## Cycle Enfield - Section 1

### A105 South of Ecclesbourne Gardens to Oakthorpe Road

Stage 2 Road Safety Audit

Ref: 2759.03.01/032/A105/BOR/2016

**DRAFT**  
 GENERAL ARRANGEMENT SHEET 3 OF 3  
 FOR COMMENTS ONLY

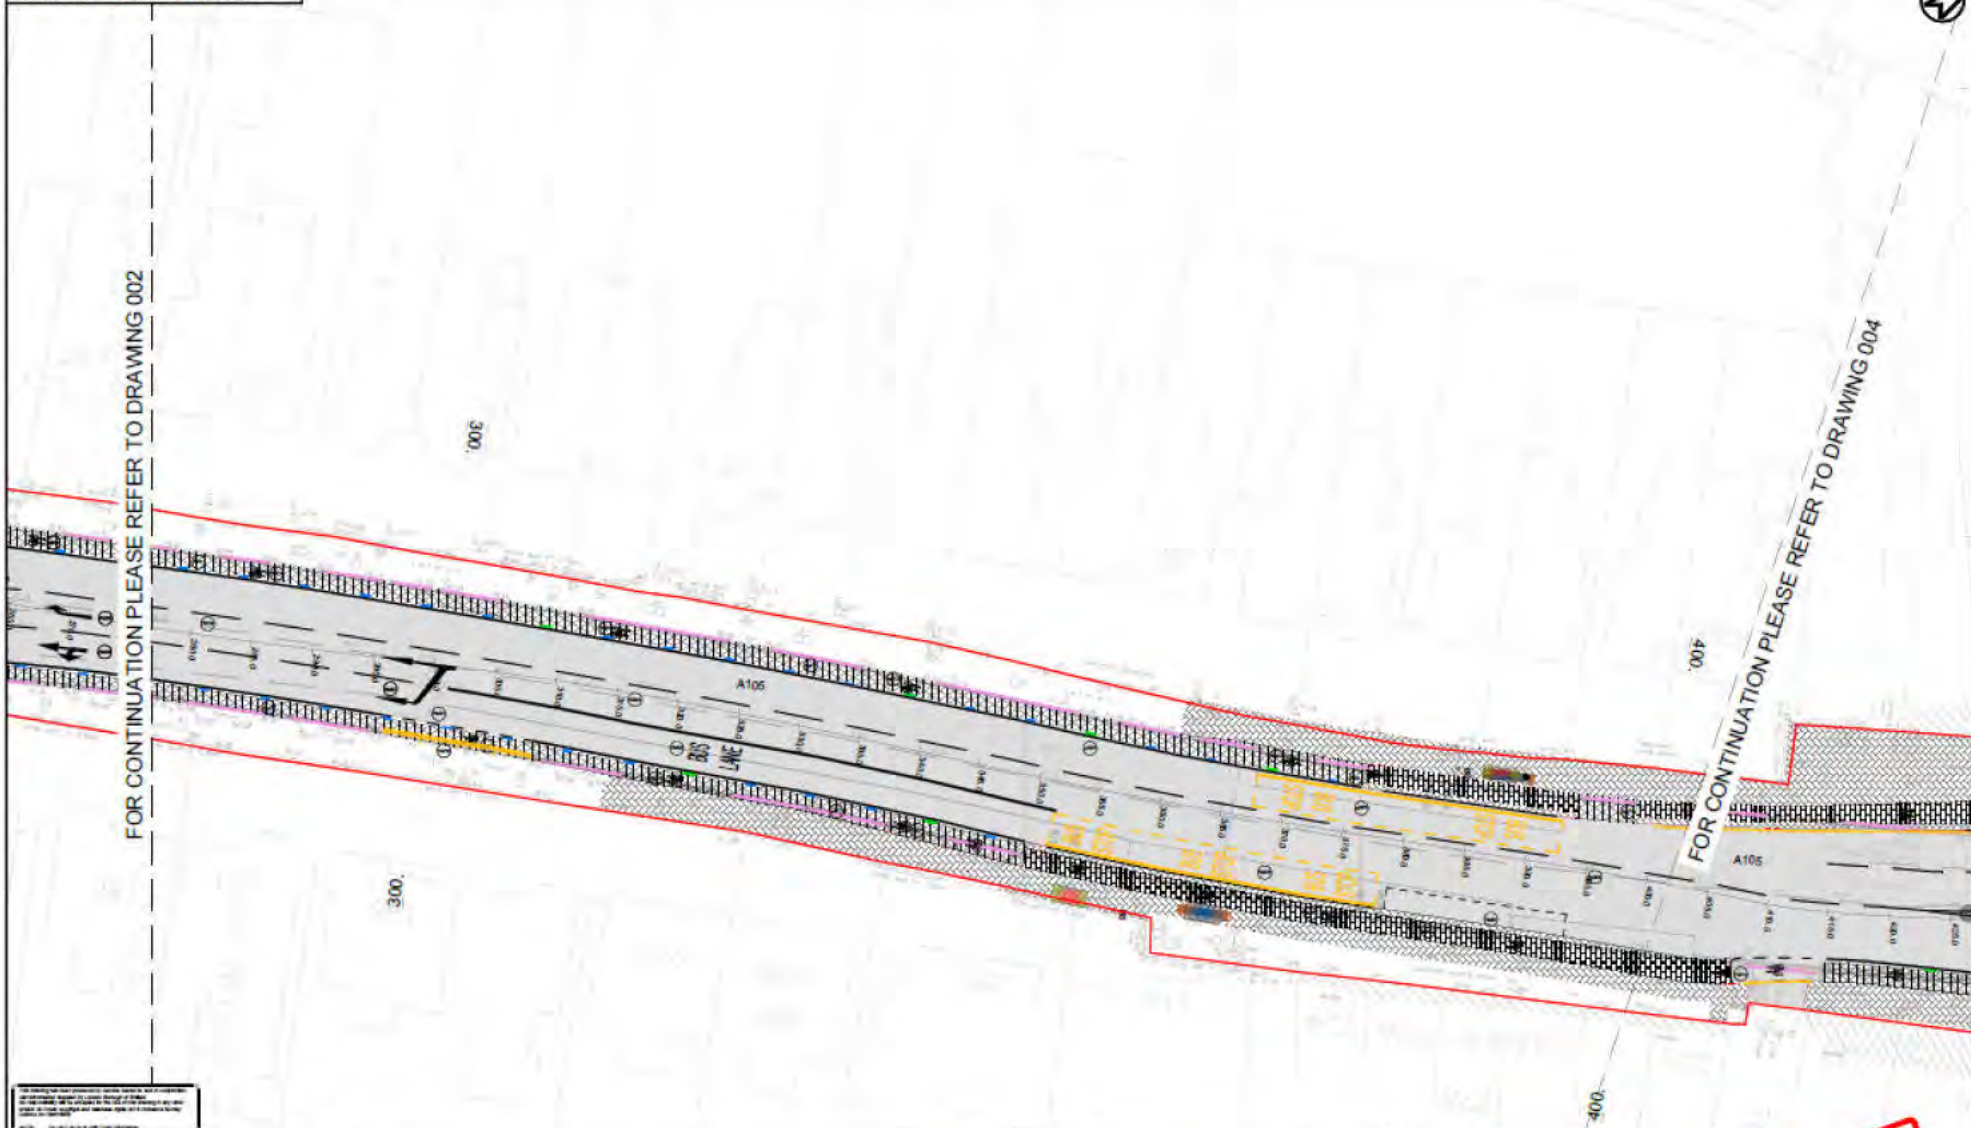
**Location:** 1 – Near building number 210 Green Lanes (Sheet 3/47)

The proposed down ramp at the head of the southbound bus stop does not appear to be shown with a road marking to highlight the change in elevation.

**Location:** 2 – Near building number 212 Green Lanes (Sheet 3/47)

It is not clear if the proposed shelter maintains an effective footway width. If this is not the case then alterations may be required to either remove the side panels from the shelter and / or relocate it.

<b>GENERAL ARRANGEMENT SHEET 35 OF 47</b>	
Drawing title: <b>FOR APPROVAL</b>	
Scale:	1:200 @ A1
Sheet No.:	B240A024
Client ref.:	-
Drawing number:	B240A024-DG-A105-0100-035

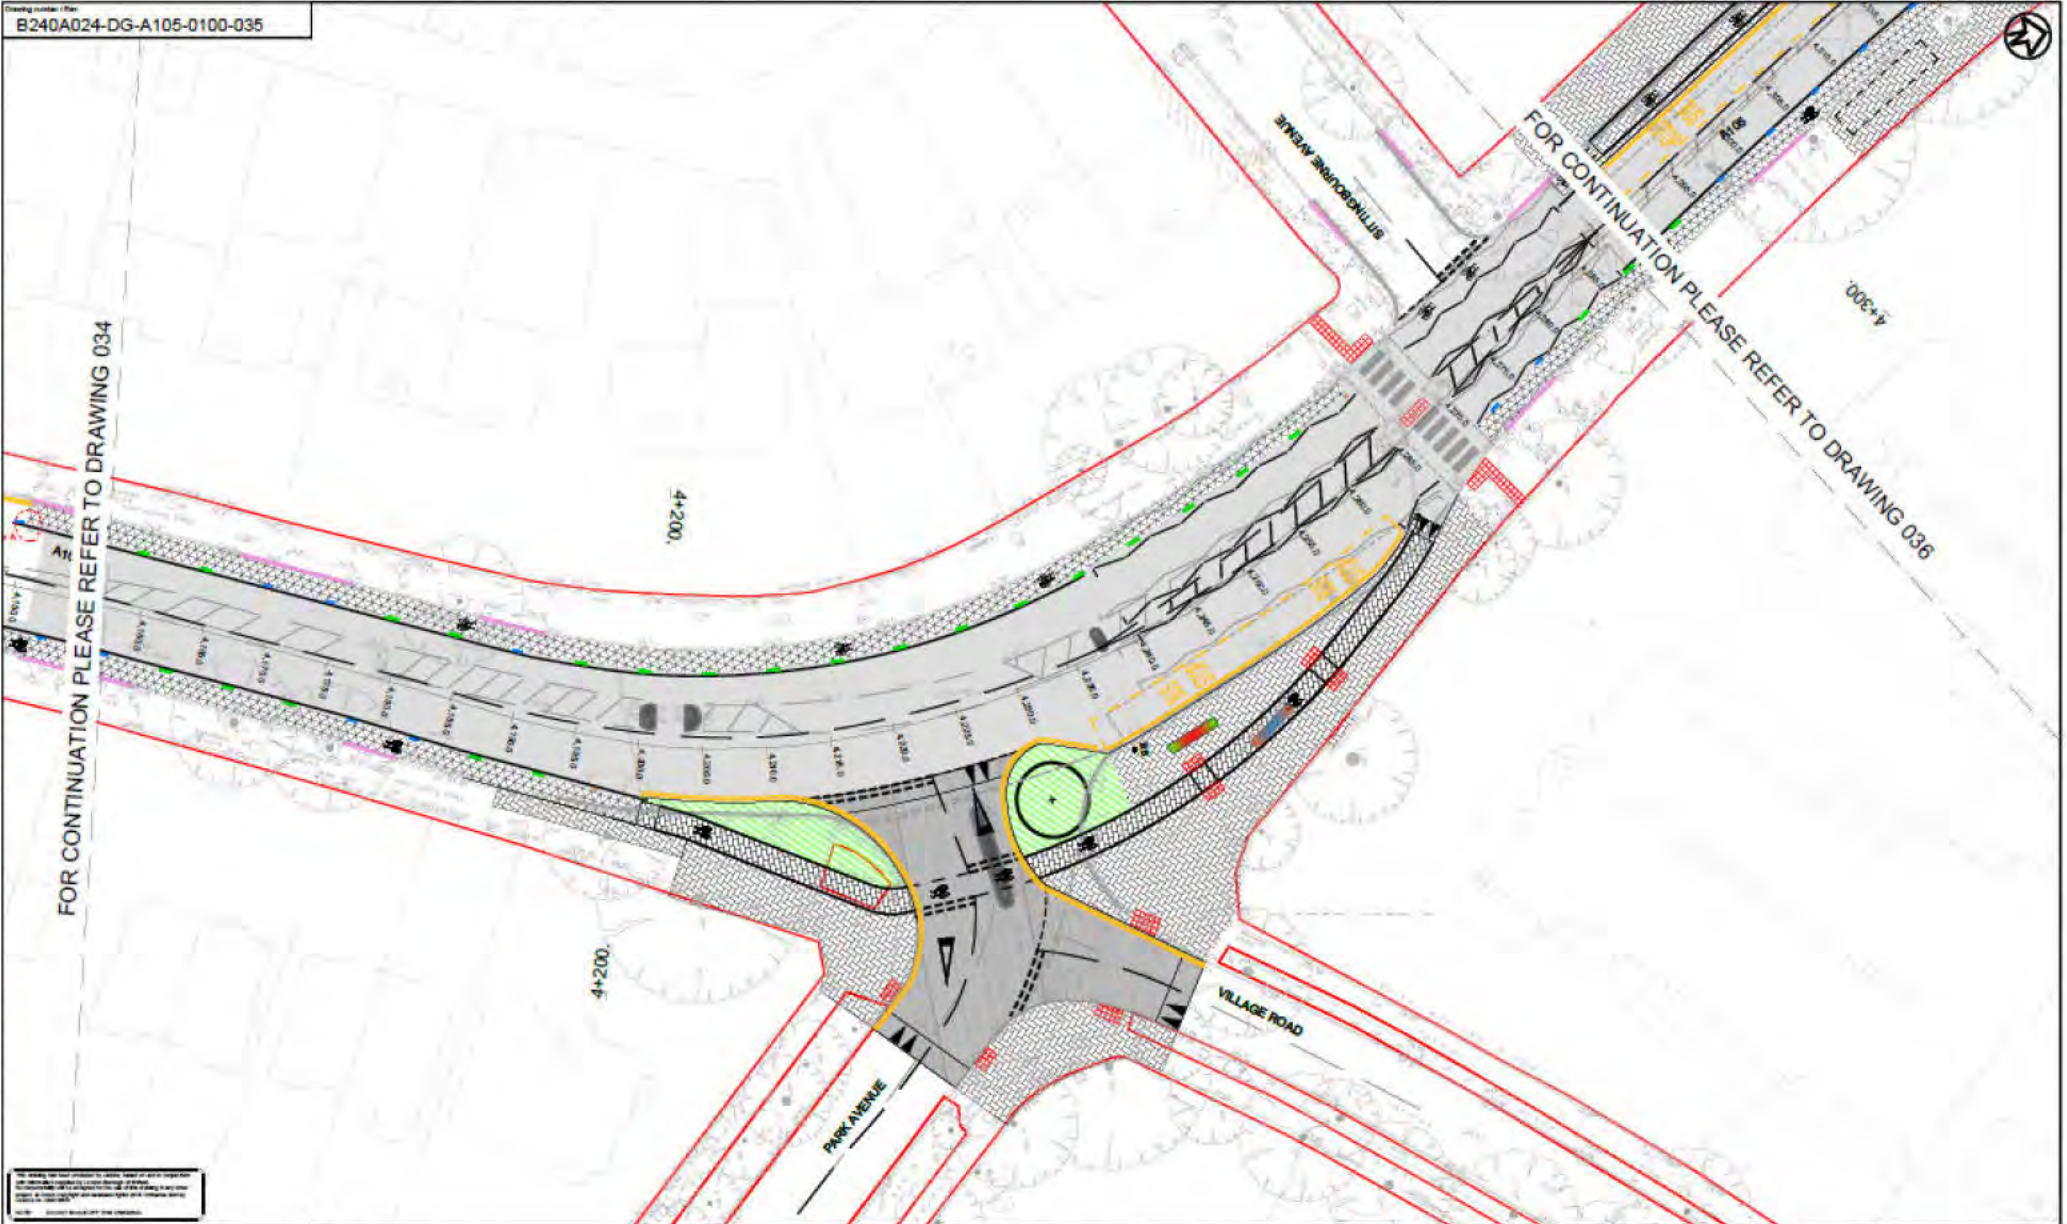
**Location:** C – A105 Village Road junction with Park Avenue / Village Road  
(Sheet 35/47)

**Location:** D – A105 Village Road junction with Park Avenue (Sheet 35/47)

Drawing title	
GENERAL ARRANGEMENT SHEET 36 OF 47	
Drawing status	
FOR APPROVAL	
Scale	
1:250 @ A1	DO NOT SCALE
Drawing no.	
B240A024	
Client no.	
Drawing number	
B240A024-DG-A105-0100-036	
Rev	
-

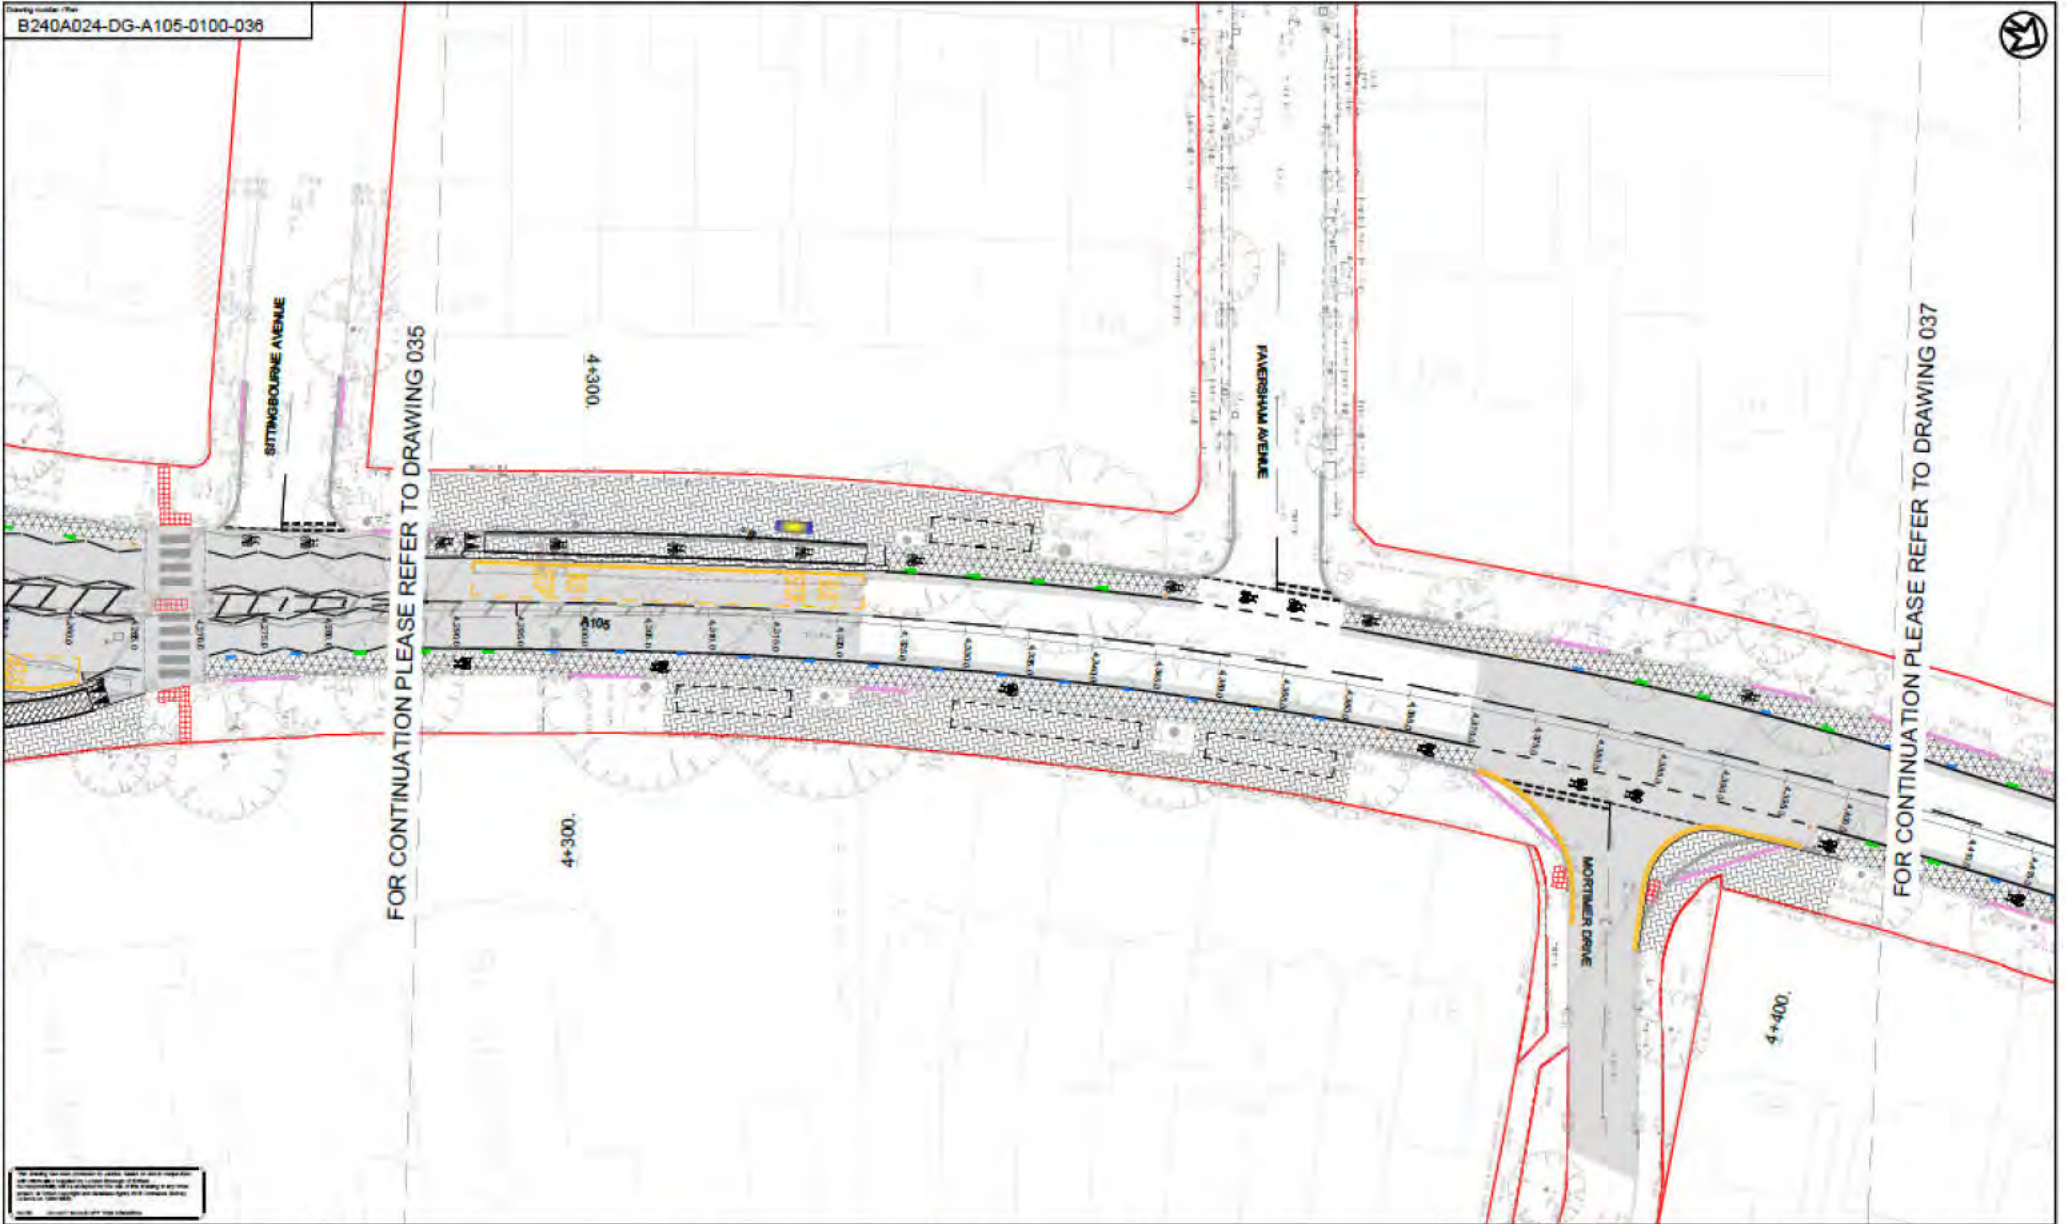
**Location:** E – A105 Village Road northbound cycle track between junction with Sittingbourne Avenue and Faversham Avenue (Sheet 36/47)

**Location:** F – A105 Village Road near junction with Sittingbourne Avenue and Faversham Avenue (Sheet 36/47)
